Administrative Board of Review Meeting
Wednesday, October 1, 2025 - 4:00 PM
AGENDA

SITE PLAN COMMENT LETTER

Request: Approval of a final development plan by the ABR based on the submitted site and architectural plans for Cologix Building 1.

SITE PLAN A

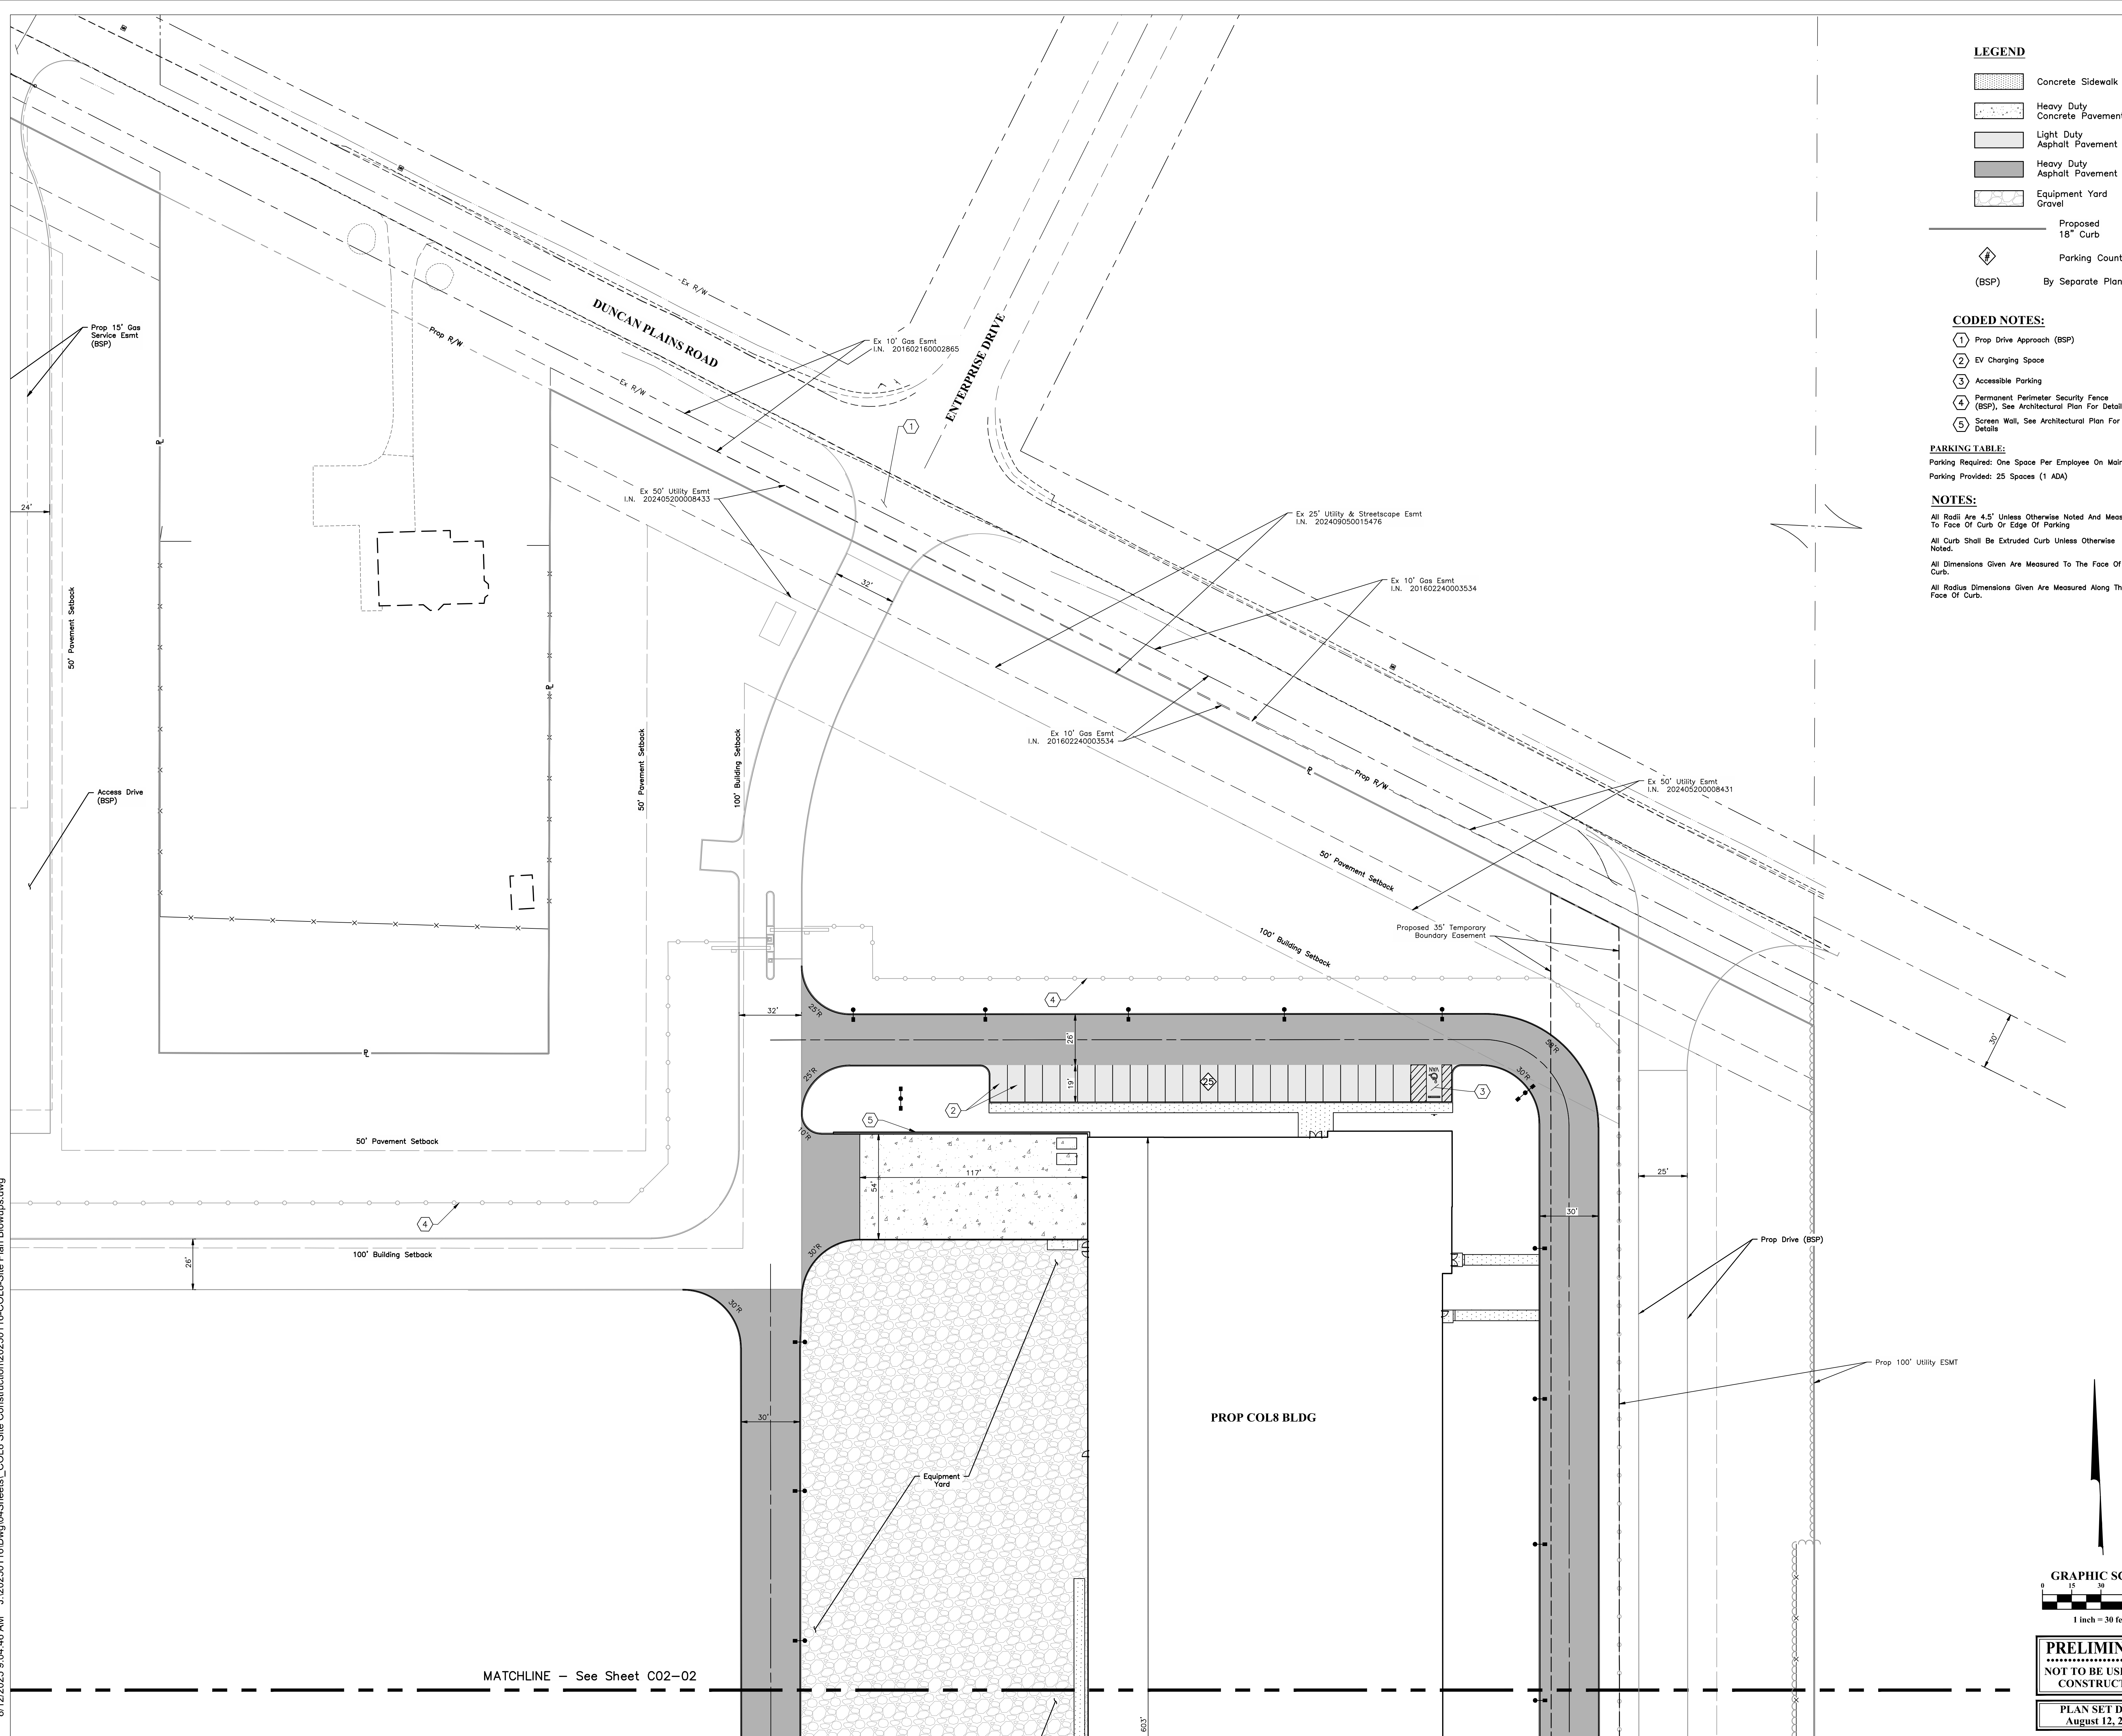
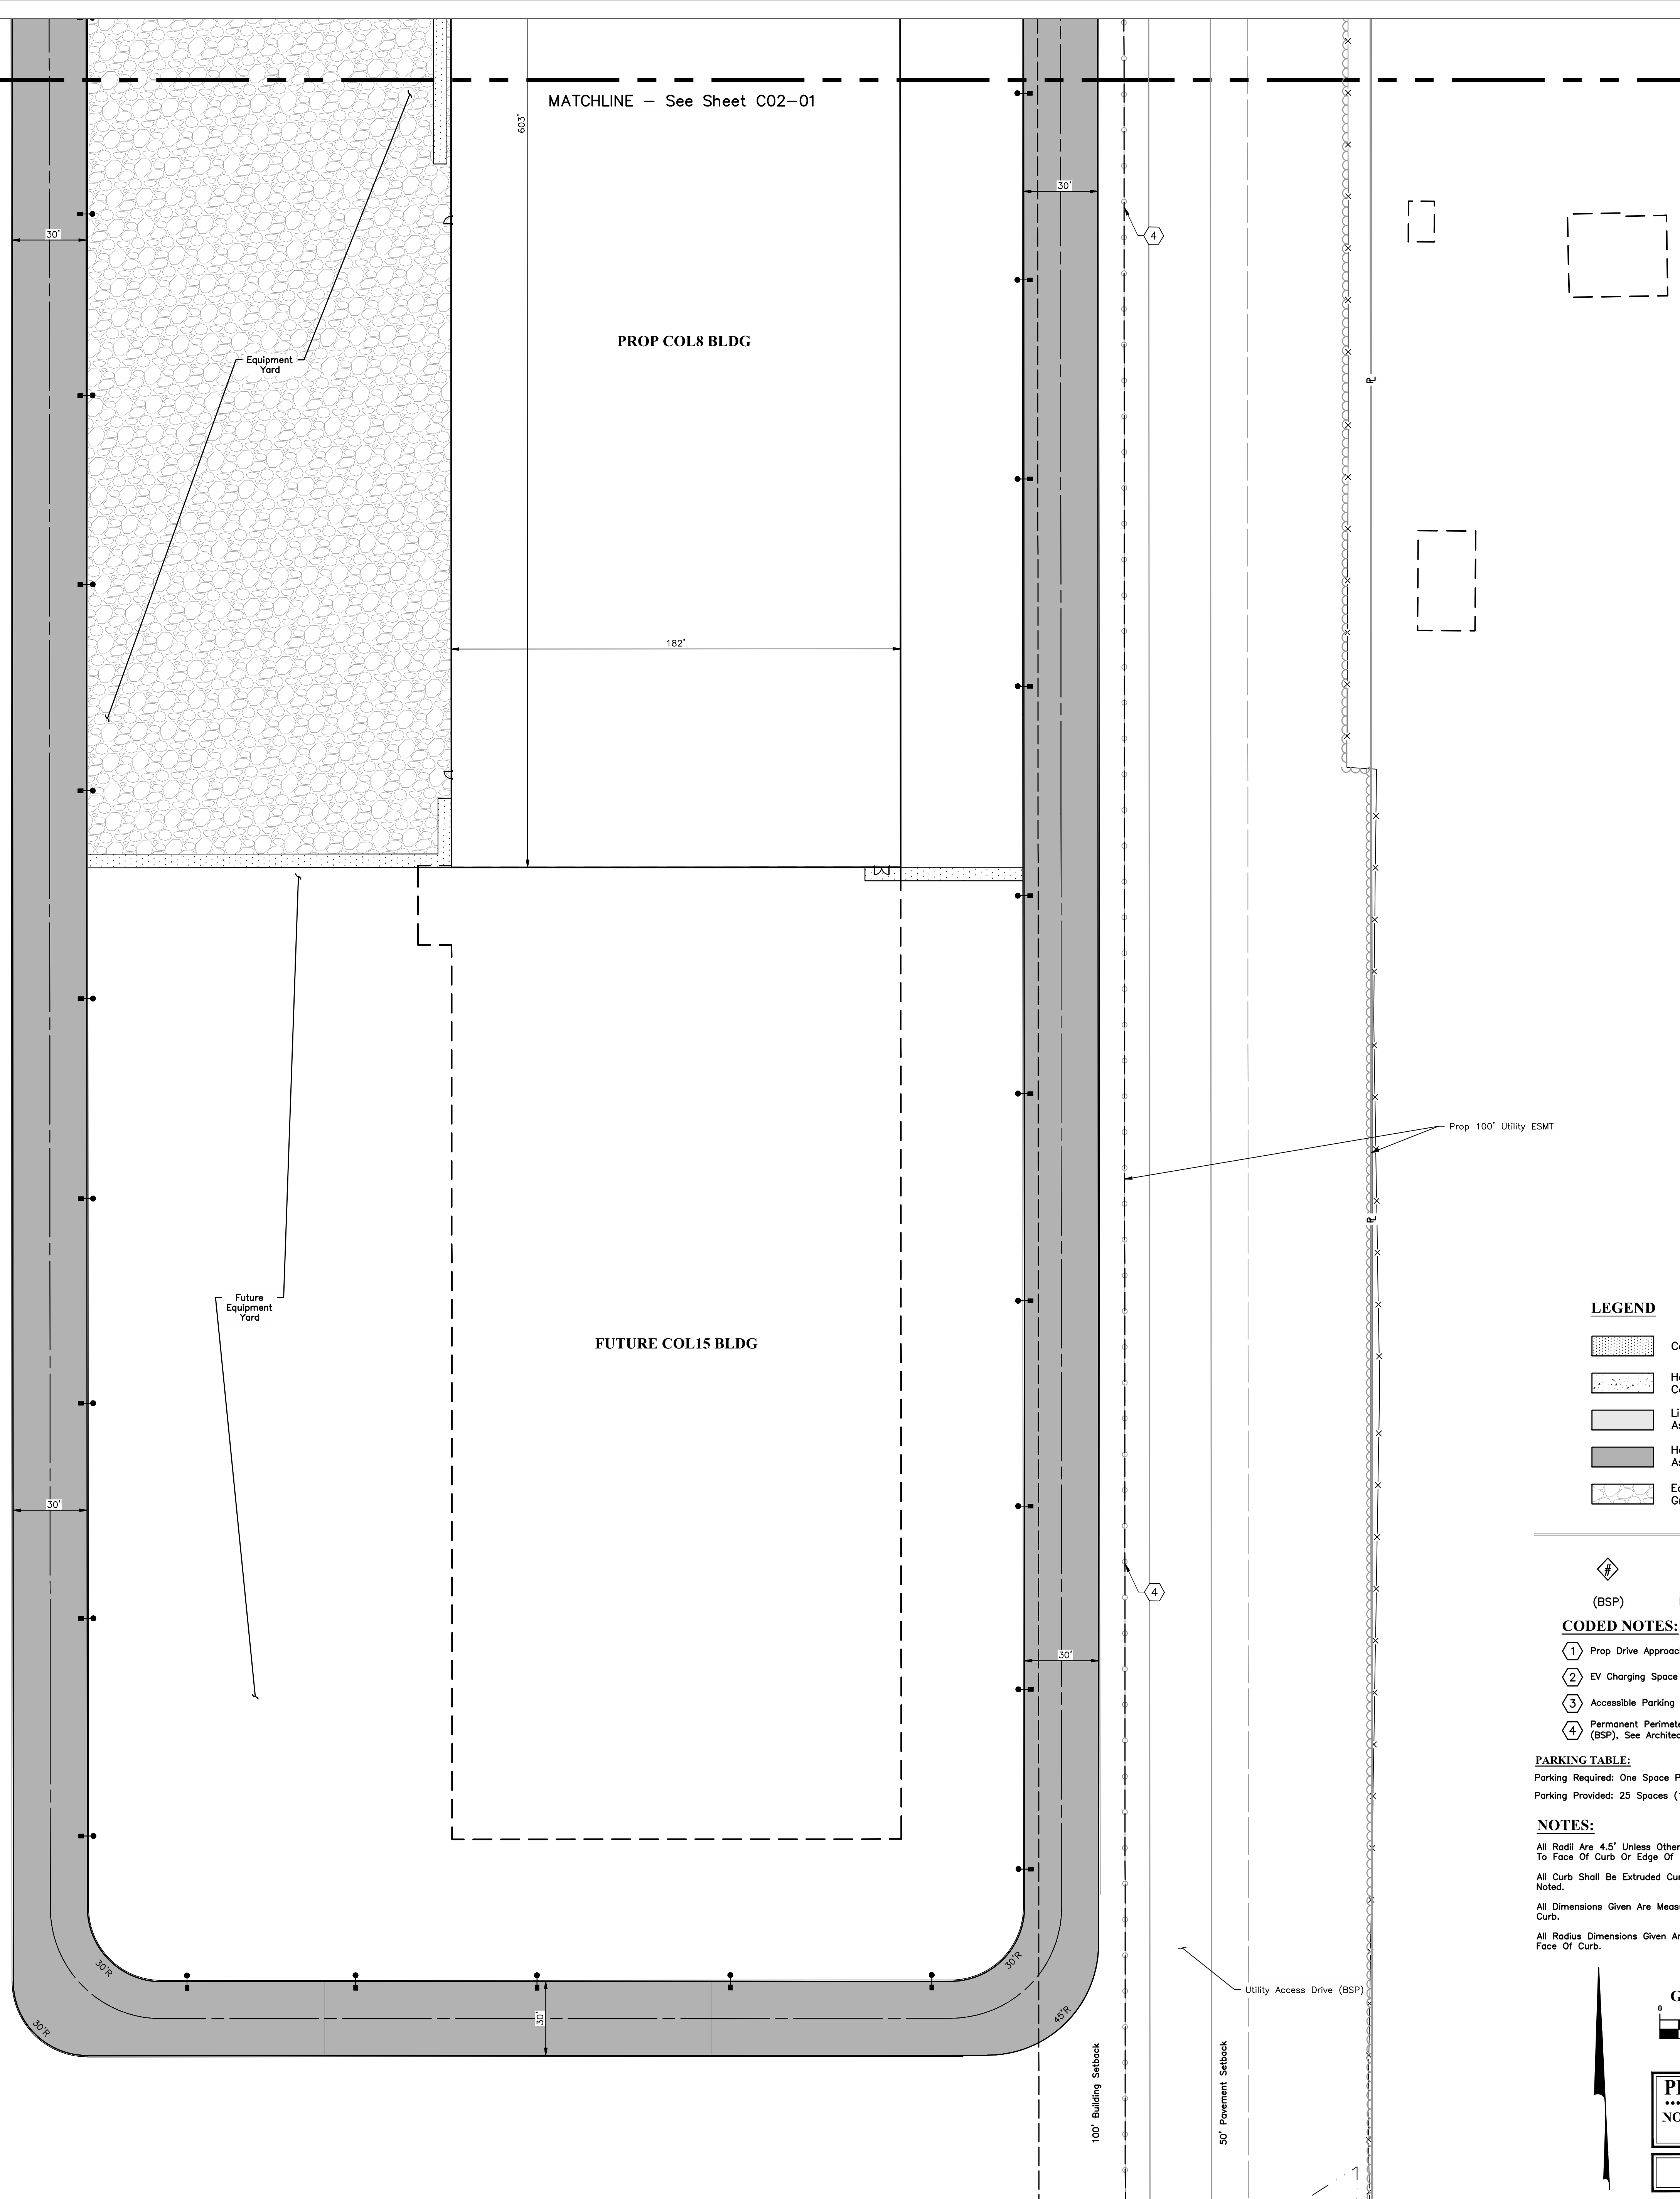
Reviewer Comment: Section 5.6(G) of the governing PD ordinance requires an 8' leisure trail to be installed. This trail has not been illustrated on the proposed site plans. A 25' easement of 25' is illustrated on the site plans along the south side of Duncan Plains Rd.
